OFFICE OF ENERGY INFRASTRUCTURE SAFETY

~~DRAFT~~ ANNUAL REPORT

PACIFIC GAS & ELECTRIC COMPANY

2020 WILDFIRE MITIGATION PLAN

Figure 1: CRU Project Circuit Mile Allocation by Equal Risk Bins

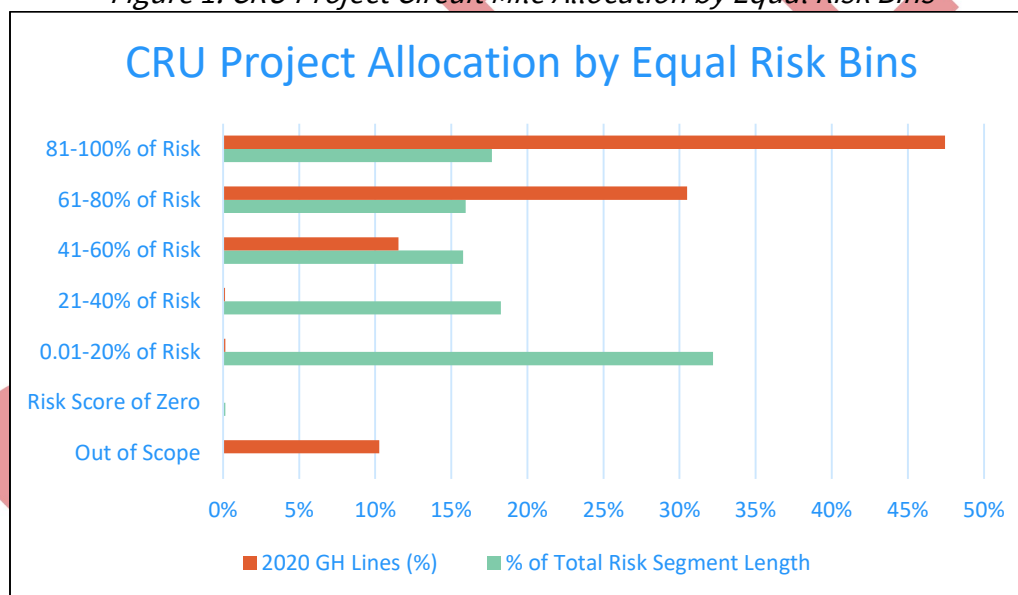
As shown in Figure 1, 10% of the CRU projects completed by PG&E in 2020 were out of the scope of this analysis. While PG&E completed nearly half of its CRU projects in its highest risk bin, as discussed above, the 61-80% and 41-60% risk bins contained more risk per circuit mile. Given the amount of CRU projects completed in 2020, more risk may have been reduced for the same number of miles completed had there been more work allocated in the 61-80% and 41-60% risk bins.

Figure 2: Vegetation Management Inspection (VMI) Point Allocation by Equal Risk Bins

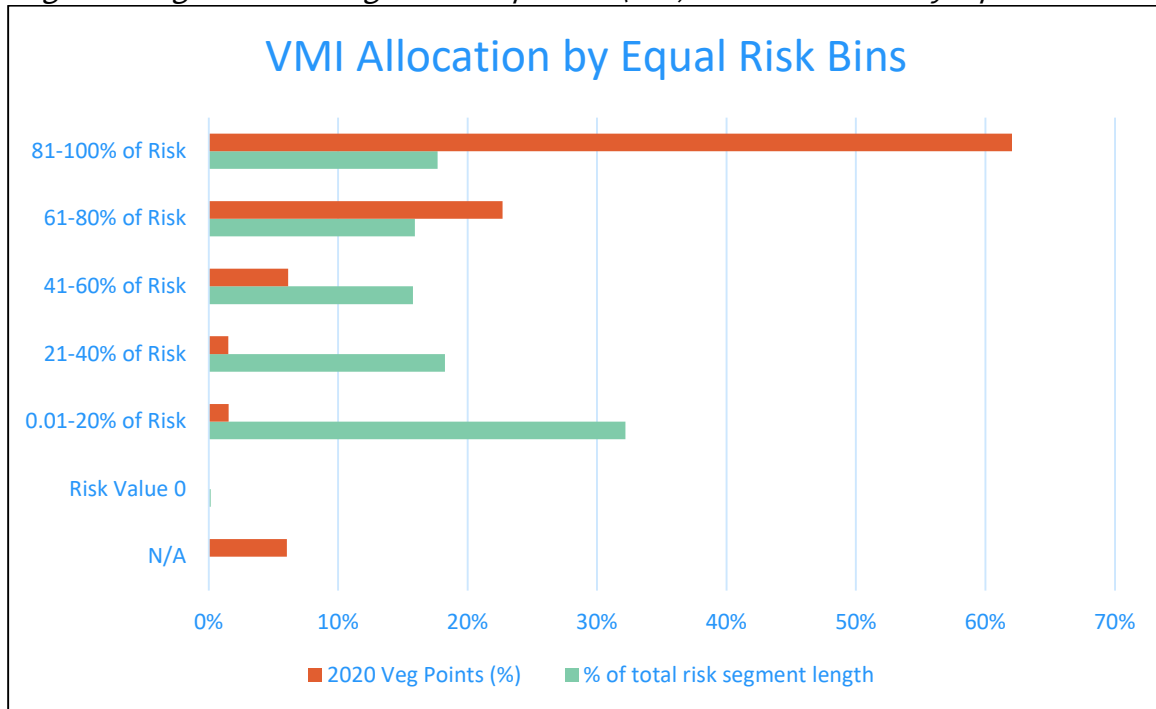
PG&E completed approximately 90% of its non-routine VMI near risk segments that make up 60% of its distribution risk.¹⁵² While PG&E completed over 60% of its VMI work in its highest risk bin, as discussed above, the 61-80% and 41-60% risk bins contained more risk per circuit mile. Given the amount of VMI completed in 2020, more risk may have been reduced for the same volume of VMI work completed had there been more work allocated in the 61-80% and 41-60% risk bins.

Figure 3: Vegetation Management Project (VMP) Point Allocation by Equal Risk Bins

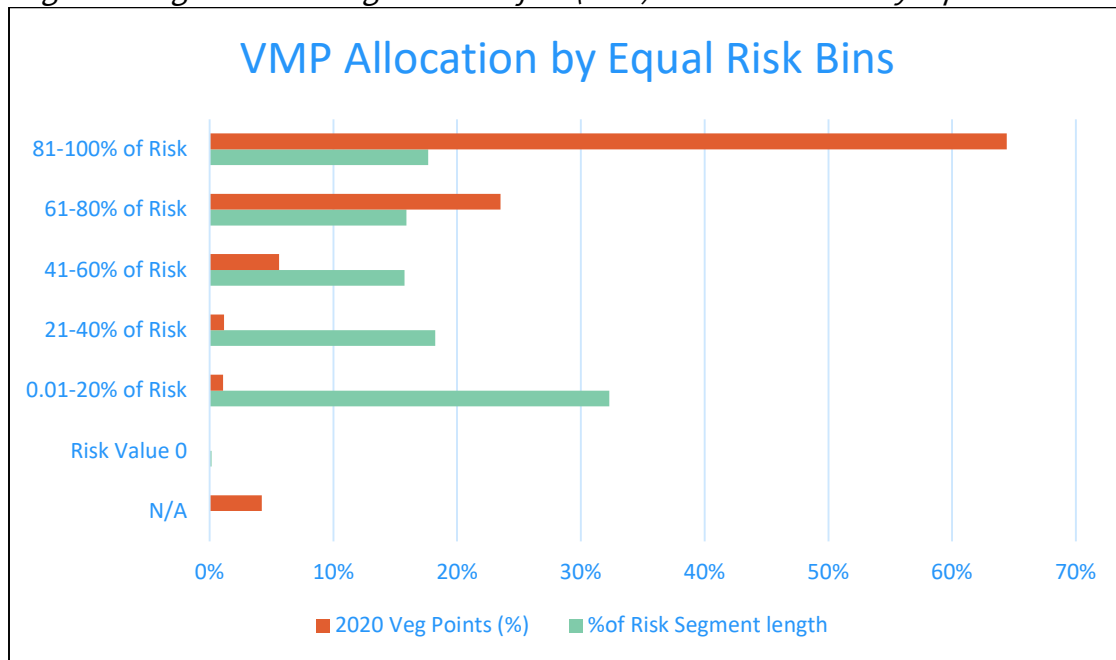
PG&E completed 88% of its non-routine VMP near risk segments making up the top 40% of riskiest segments.¹⁵³ While PG&E completed over 60% of its VMP work in its highest risk bin, as discussed above, the 61-80% and 41-60% risk bins contained more risk per circuit mile. Given the amount of VMP work completed in 2020, more risk may have been reduced for the same volume of work completed had there been more work allocated in the 61-80% and 41-60% risk bins.

Figure 12: PG&E Total Wire Down Events from 2015-2020 Normalized by RFWCMD.¹⁷⁶

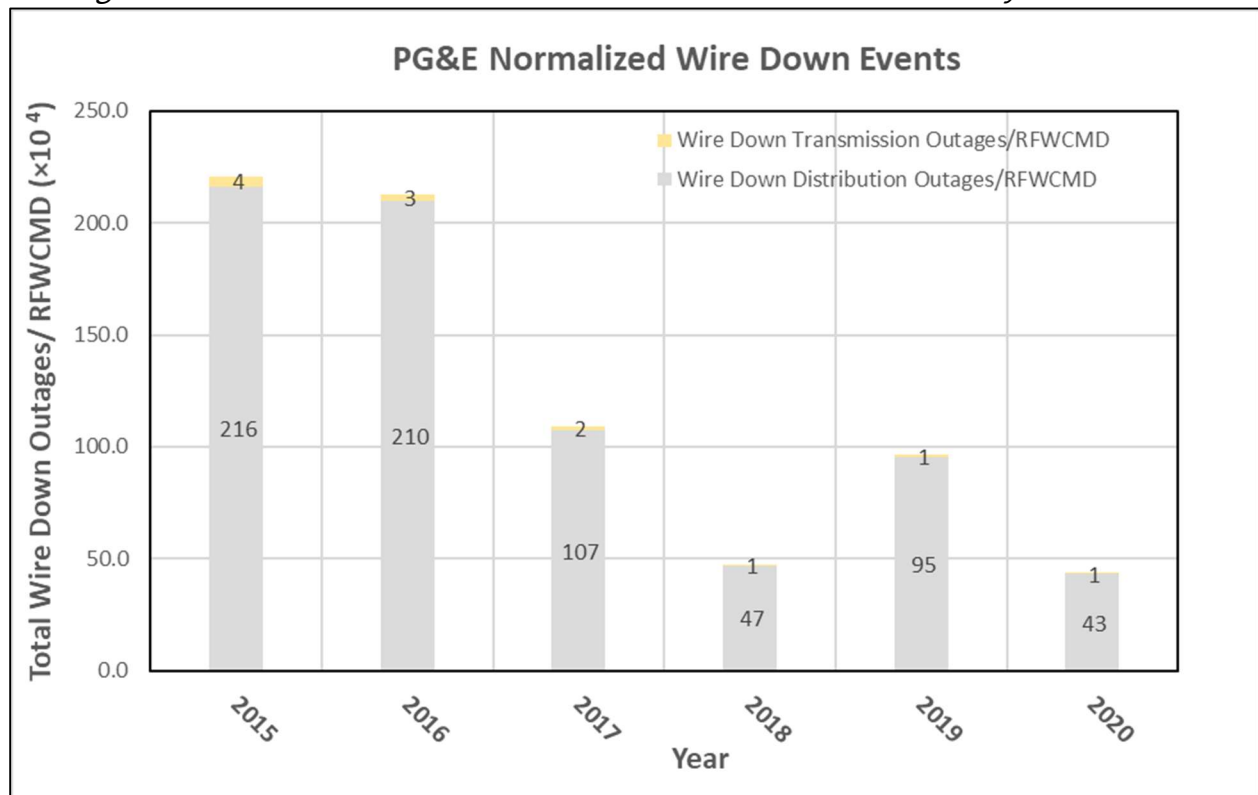
Although there was an uptick in 2019, normalized wire down events trended lower over the 2015-2020 timeframe.

Figure 13: PG&E Outages from 2015-2020 Normalized by RFWCMD.¹⁷⁷

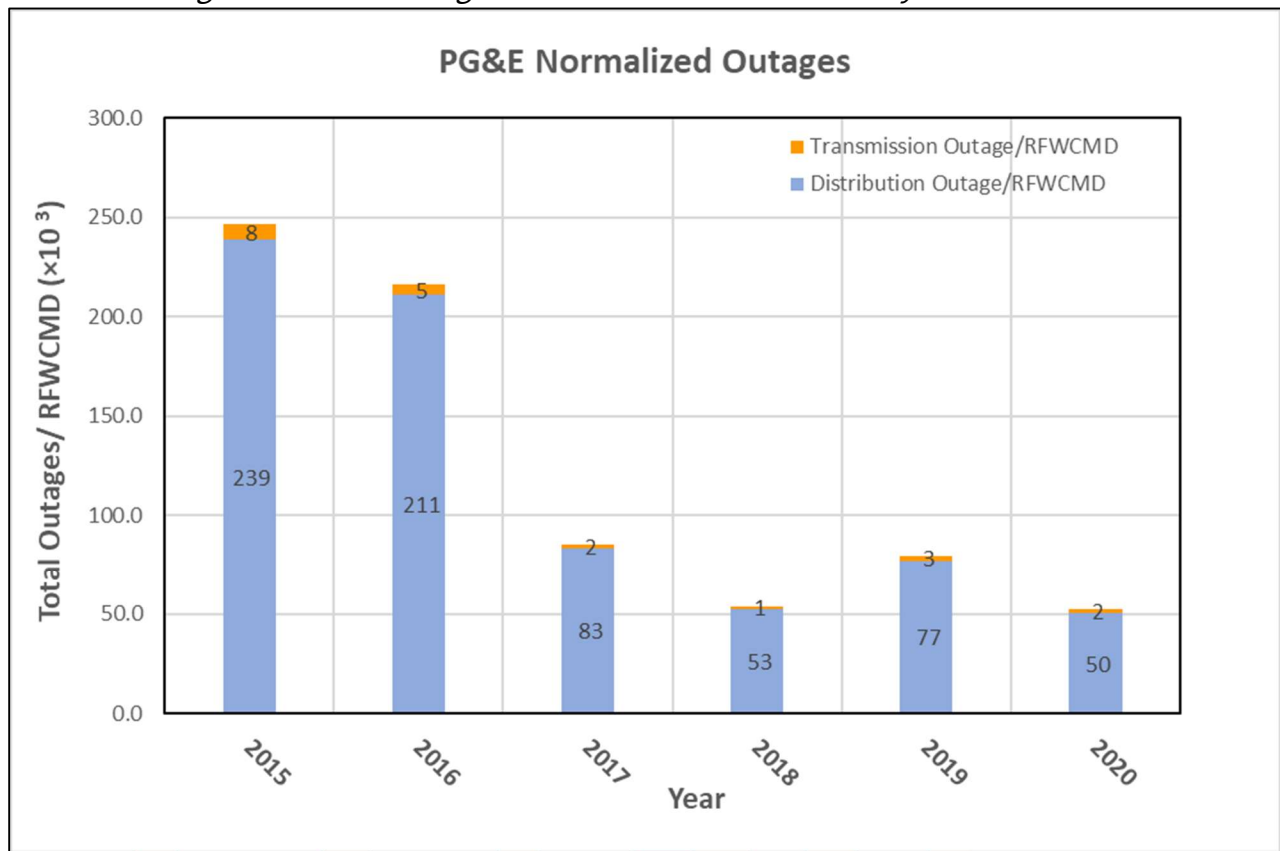
Although there was an uptick in 2019, normalized total unplanned outages trended lower over the 2015-2020 timeframe.

Figure 14: PG&E Vegetation Contact Outages from 2015-2020 Normalized by RFWCMD.¹⁷⁸

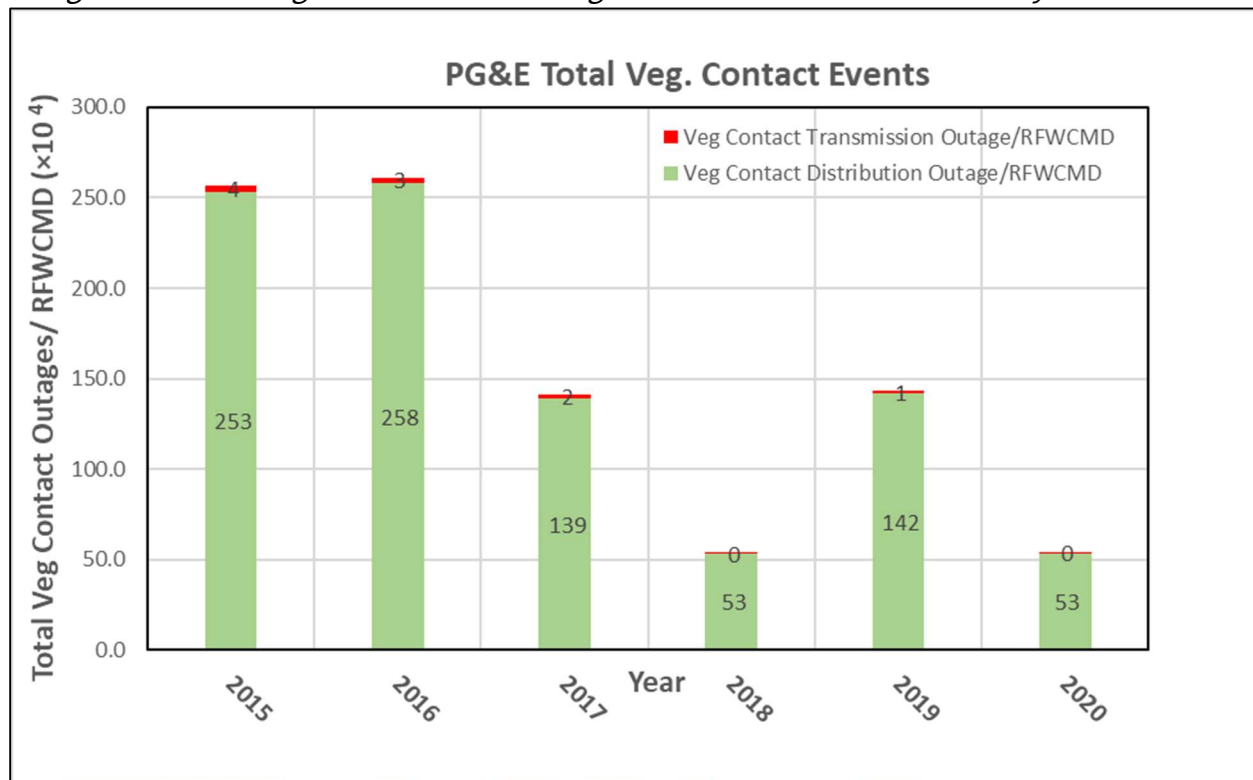
Although there was an uptick in 2019, normalized outages due to vegetation contact trended lower over the 2015-2020 timeframe.

Figure 20: Acreage burned by utility-ignited wildfire.¹⁹³

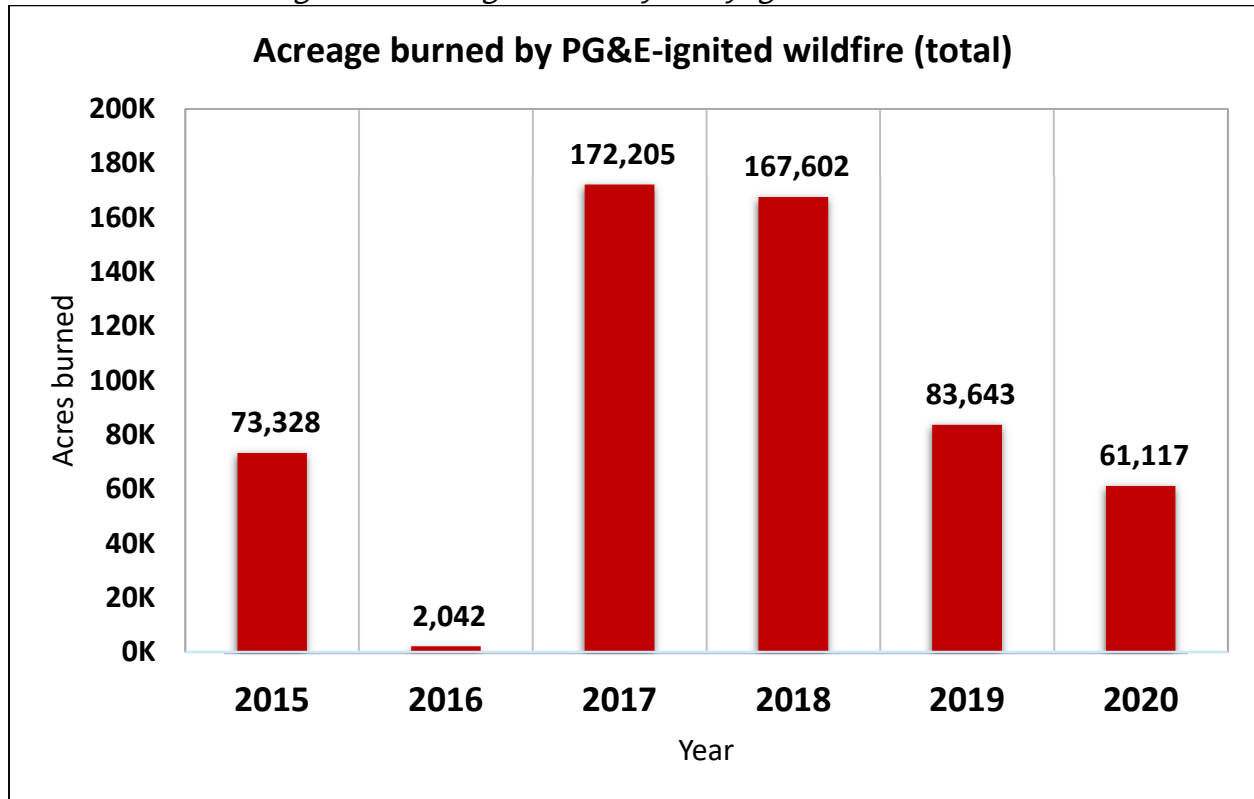
As shown above, the acres burned from wildfires ignited by PG&E's infrastructure over the six-year reporting period generally follows a normal distribution and indicates a decline since 172,205 acres burned in 2017.
